**RE: Addendum No. 1**

**PROJECT: Request for Bid – Health Sciences 226 & 236 Rehabilitation**  
**HVAC Replacement, RFB 2425-1**

**DATE OF ADDENDUM ISSUE: February 26, 2025**

**1 LEVEL 2 POWER PLAN**  
1/4" = 1'-0"

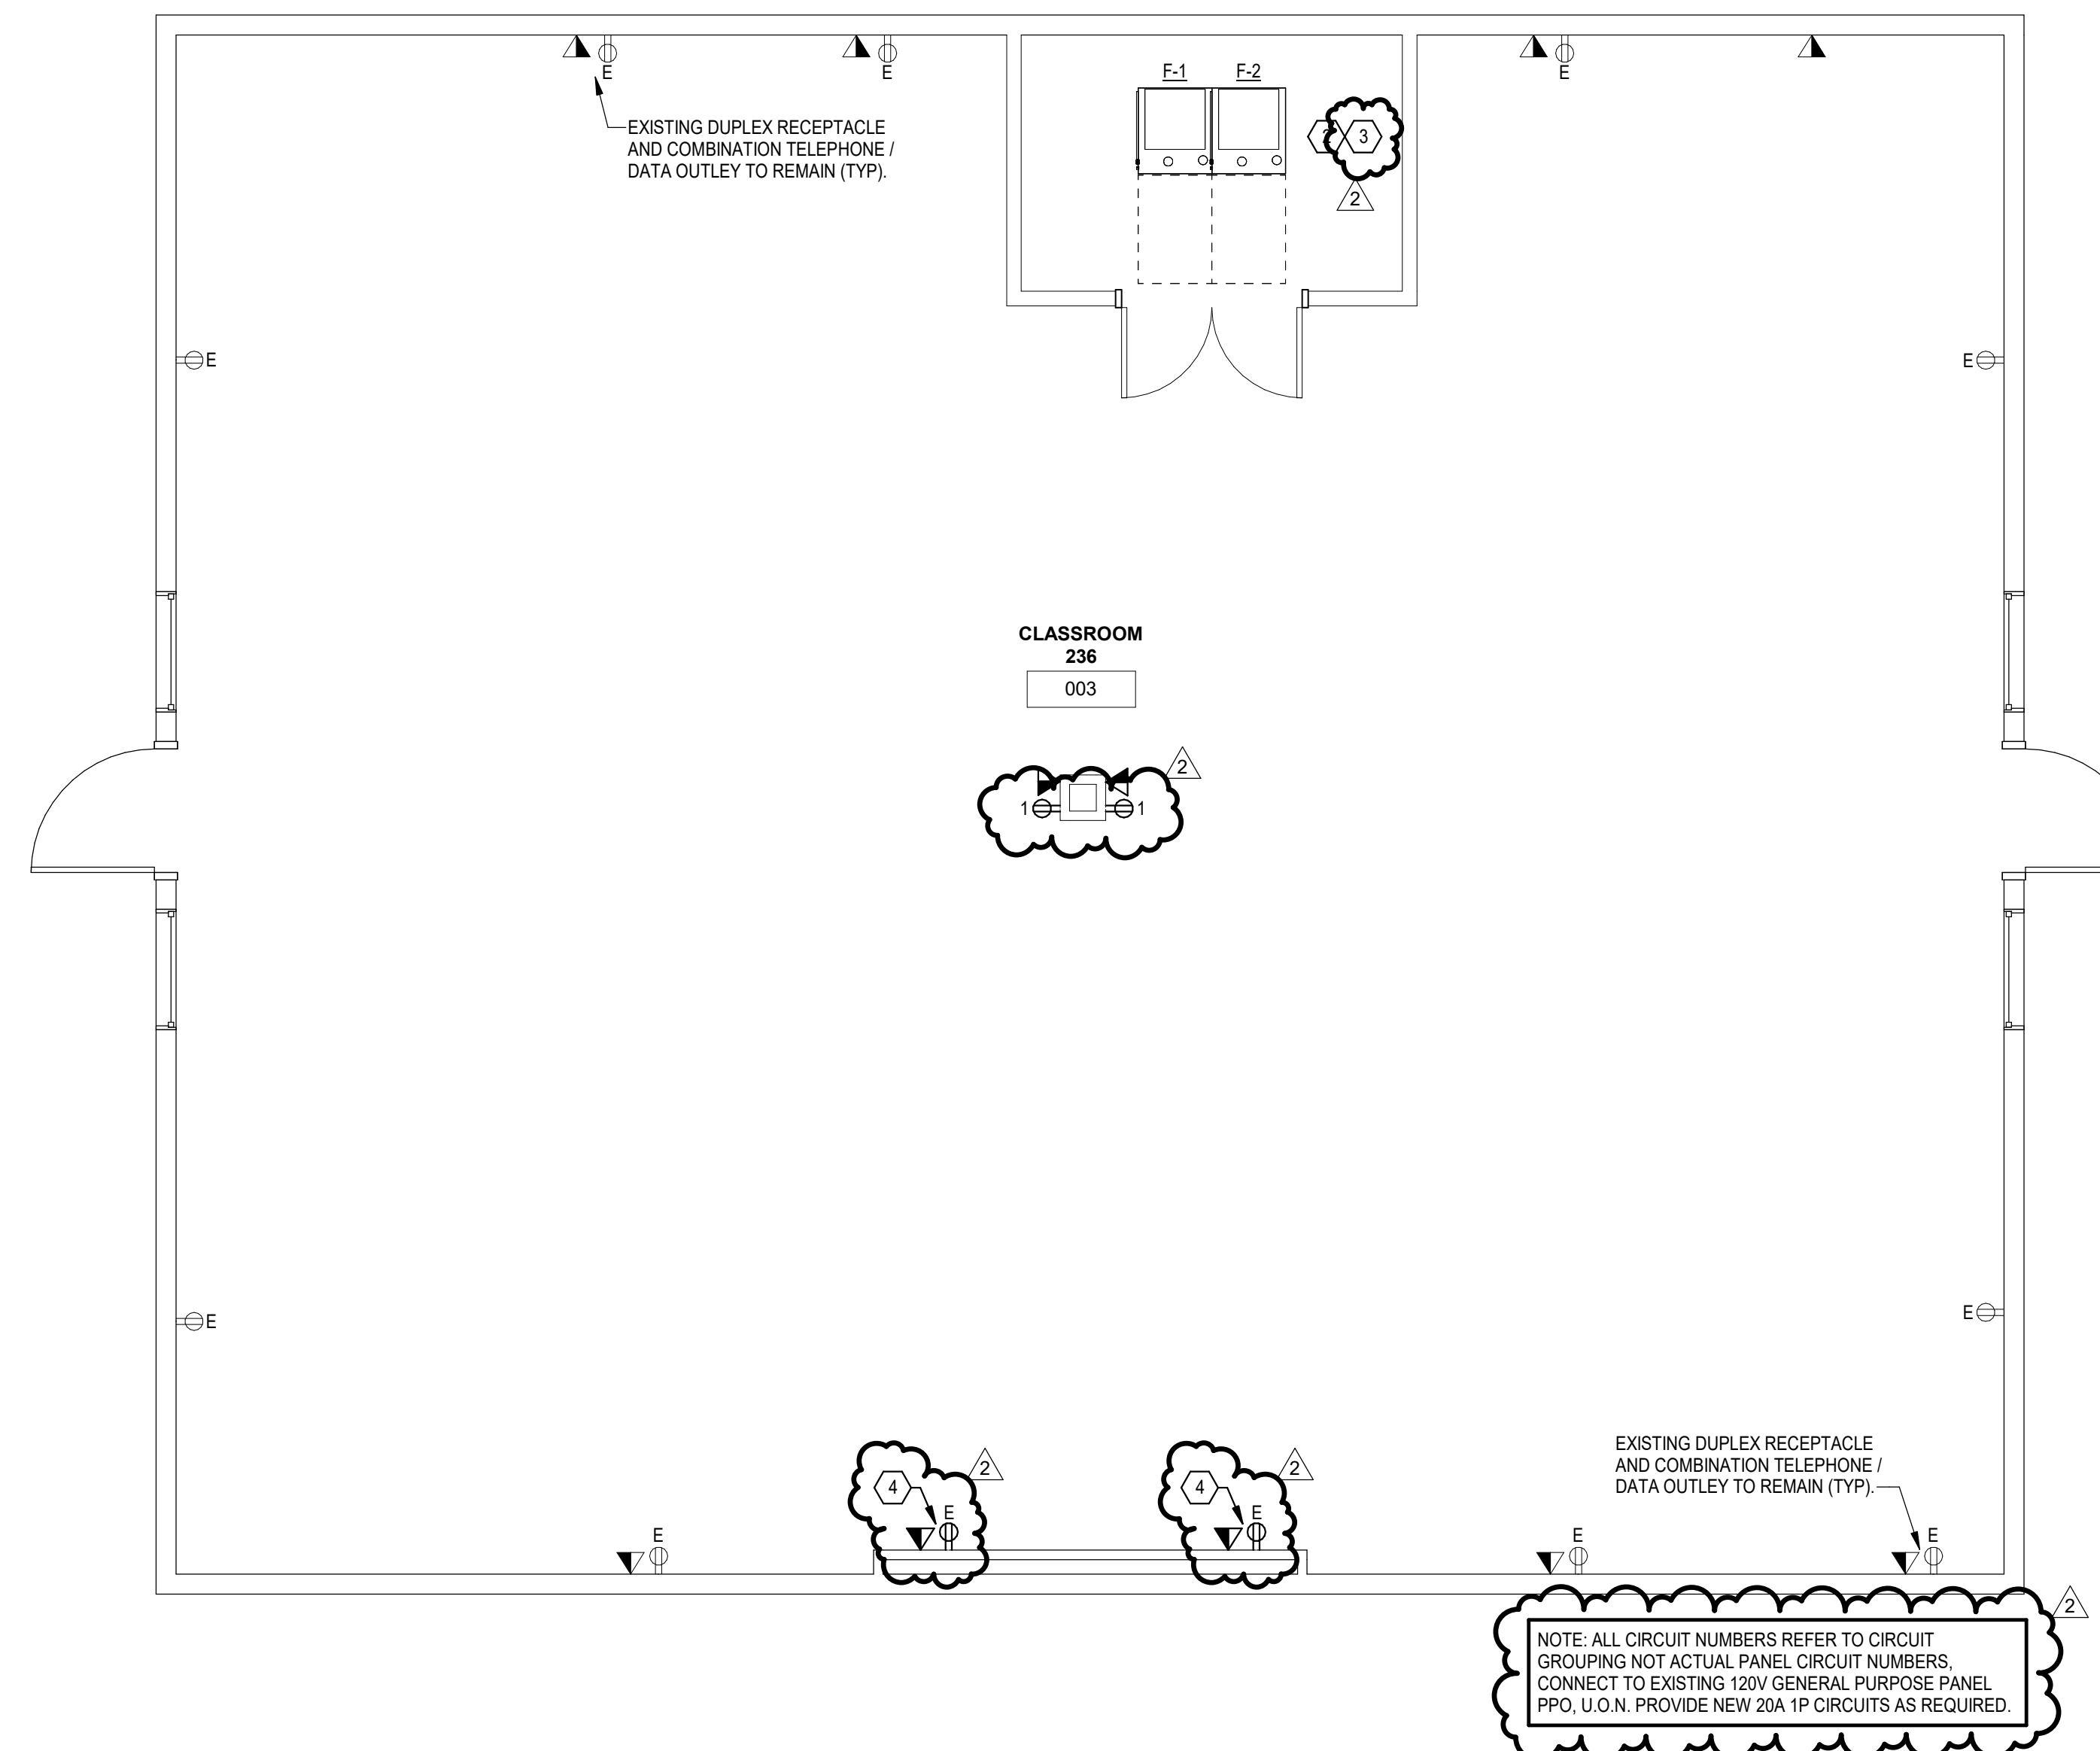
**Item NO. 9 – Question -- Are we adding and new receptacles to level 2? it's not clear what is ETR and what is new.**  
**Answer - Yes. New and ETR receptacles clarified in Addendum 1**

**Item No 11 – Question - Is any of the roof work in our scope?**  
**Answer - Yes, the existing roof mounted condensing unit is being replaced. Refer to Addendum 1 for electrical scope.**

**Item No. 2 – Contractor to provide and install in room 236, lighting dimmer controls for the new lighting system, per the drawings.**

**Item No. 5 – See attached sheets M001, M002, M101, E101 for associated Clarifications, Additions, and/or Changes.**
